Number	Description
1	Revised Table of Contents; Revised NTB Nos. 458, & 459; Added NTB No. 460; Revised Bid Items; Revised or Added Plan Sheet Nos. 2,8-10,17,3001,3004,3006,3013-3017, & 3020; Amendment EBS Download Required.

MISSISSIPPI DEPARTMENT OF TRANSPORTATION
TABLE OF CONTENTS

PROJECT: HSIP-0003-01(192)/107127301 - Hancock

ADDENDUM

SHEET NUMBER 3016

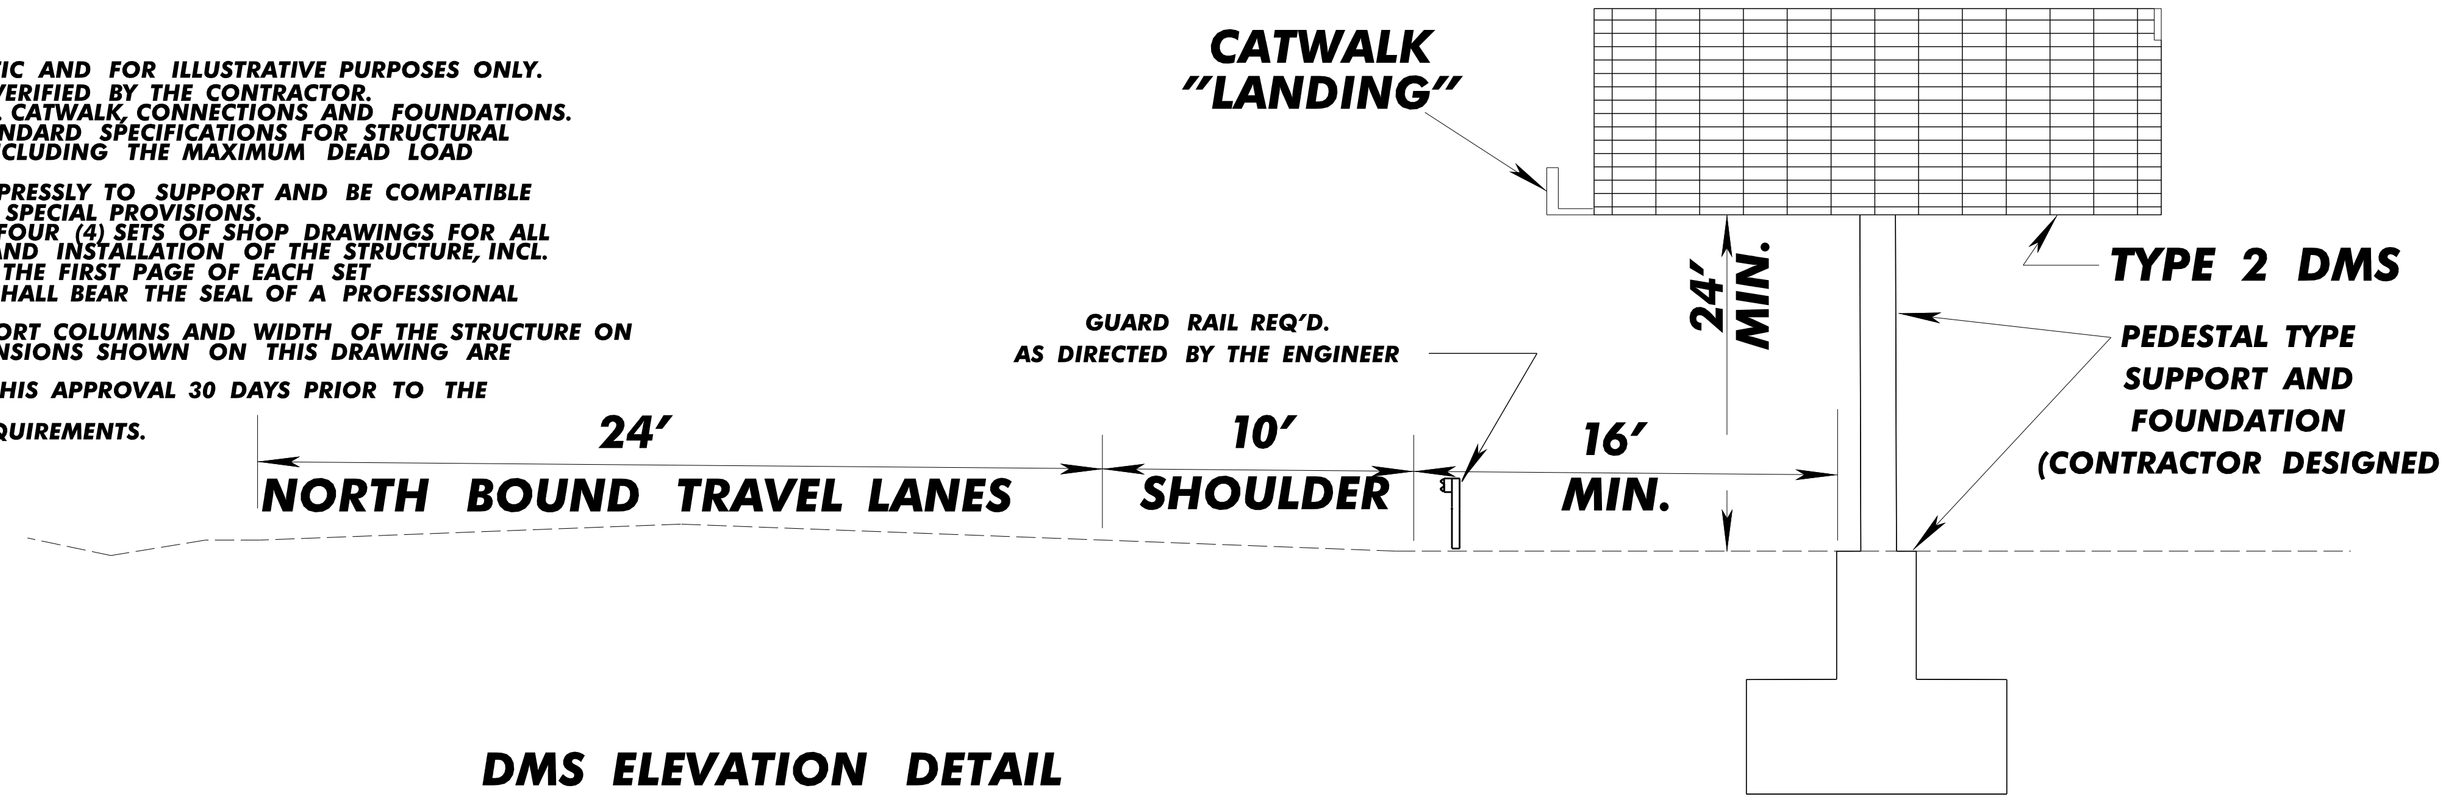
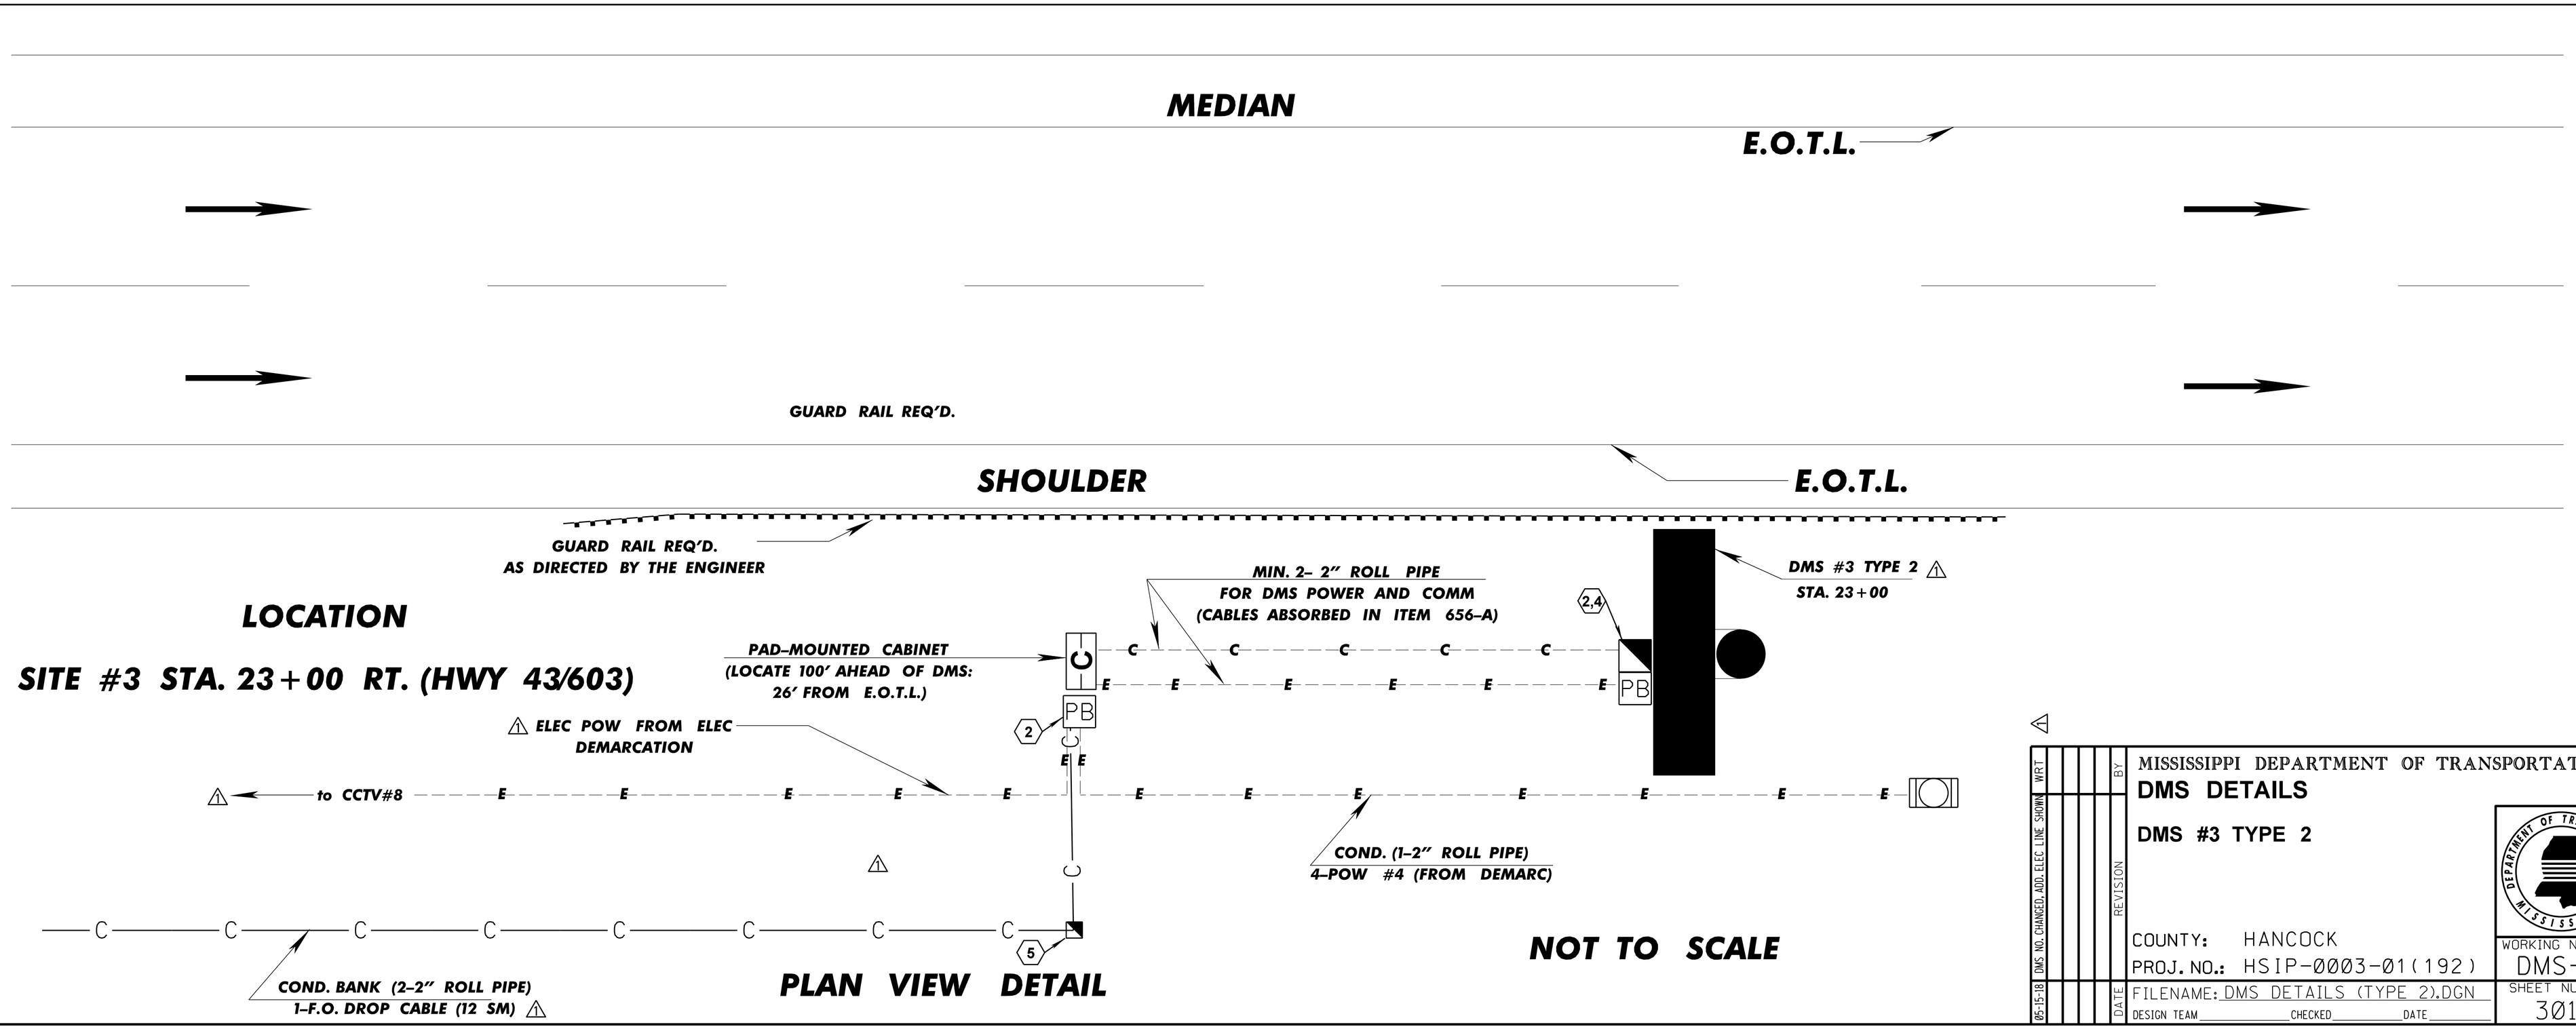
DATE	REVISION	BY
05-15-18	DMS NO. CHANGED, ADD. ELEC. LINE SHOWN	WRT
